PARTS LIST FOR MODEL SLAMMER III 4500

Model # SLA4500 (aka SLAiii4500)

MRP Ver 010120
(based on Penn's Rev. 1 07-01-17)

Penn Reel Parts list for Model: SLA4500 (SLAiii4500) SLAMMER iii SPINNING (AUTOMATOIC BAIL TRIP)

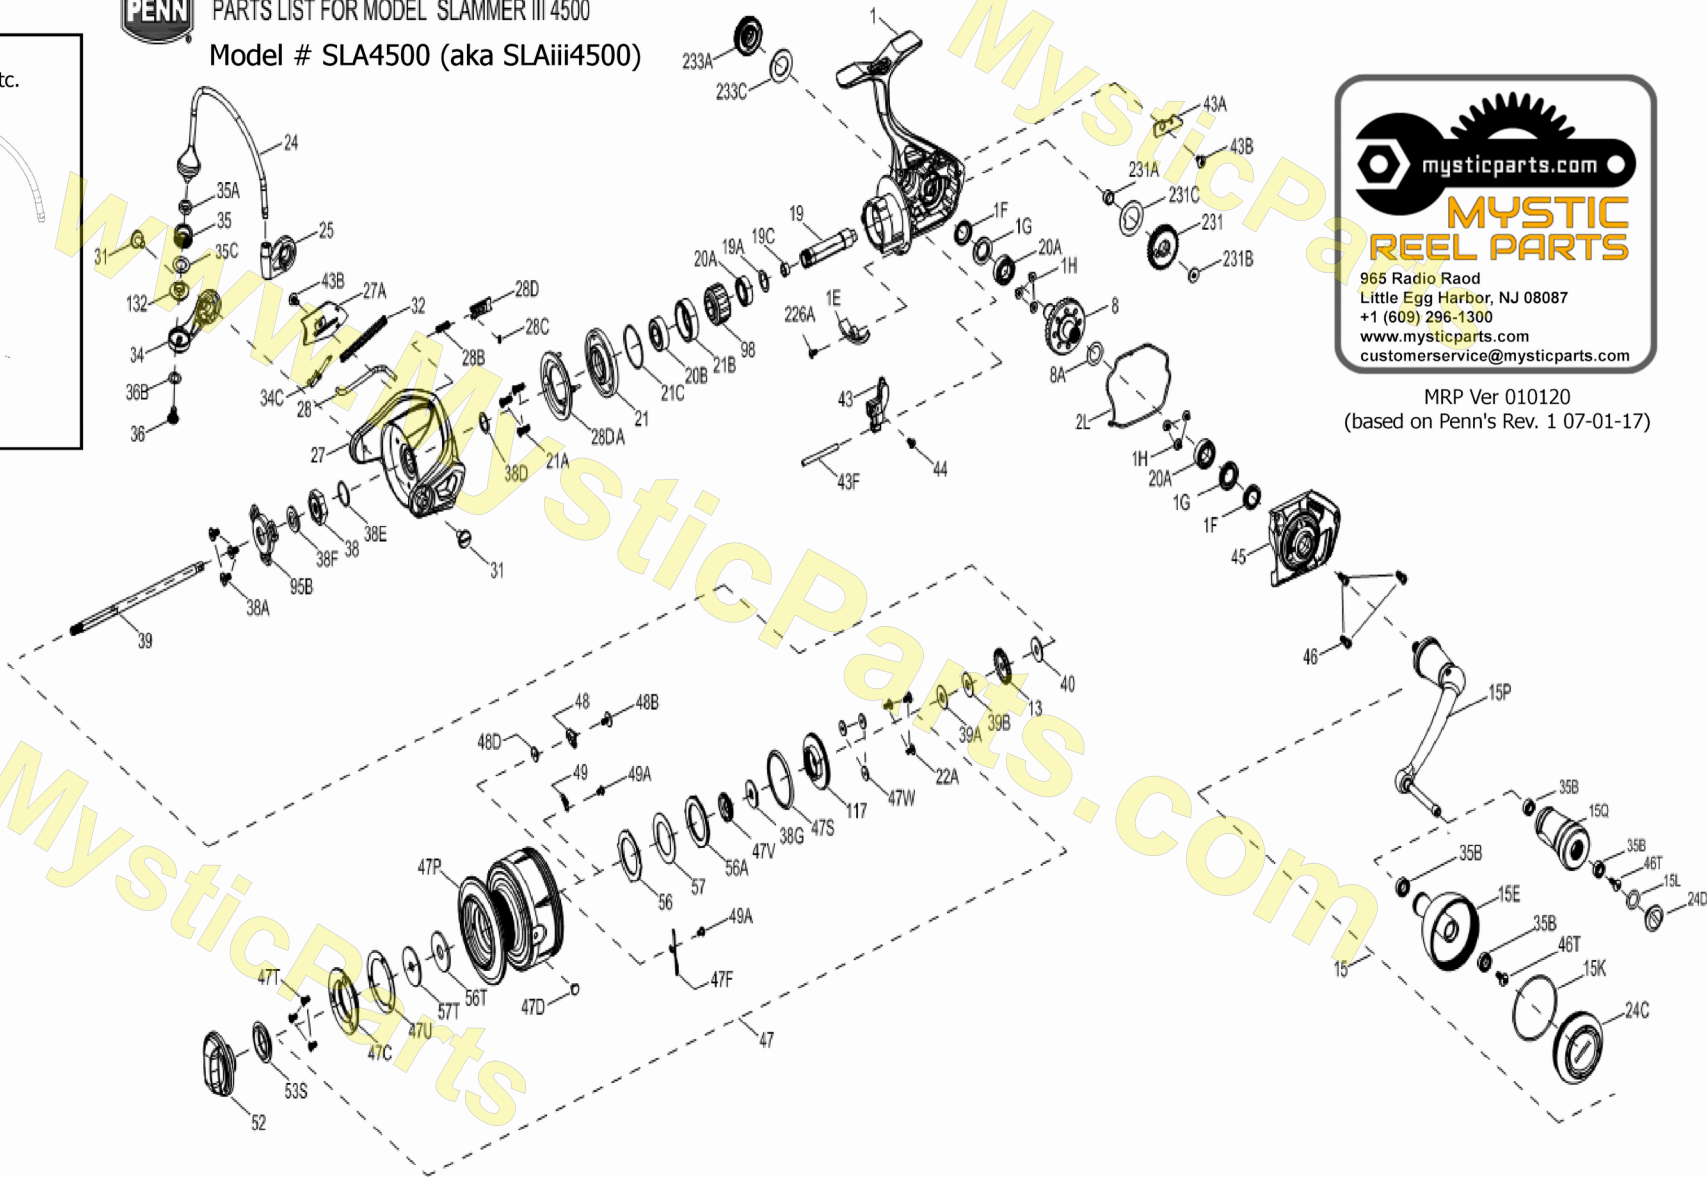
BAIL WIRE, LINE ROLLER PARTS CHANGED FOR REV 1

PROBLEMS FOUND WHEN TAKING NEW EARLY REELS APART:

39B AND 40 ON THE SLA3500 AND SLA4500 REELS WERE IN REVERSED POSITIONS

THE 39B METAL WASHER WAS FOUND BELOW THE 13 RATCHET ON THE SHAFT INSTEAD OF ABOVE IT

39A THERE MAY BE MORE OF THESE PLASTIC SHIM WASHERS THAN SHOWN ON THE DIAGRAM

POSITIONING MAY ALSO BE ALTERED AS THEY SHIM IT TO GET THE SPOOL TO A SPECIFIC POSITION ON THE SHAFT

CHANGES AND CORRECTIONS:

The original schematic listed 20A-CLA3000 which is TOO SMALL - DO NOT USE IT

20A	1385532	20C-CLA3000	SEALED BALL BEARING (3 REQUIRED)
		CORRECTED

found after release of rev 1 schematic and added notes 11/19/19

we will update this if they correct the part in their bins
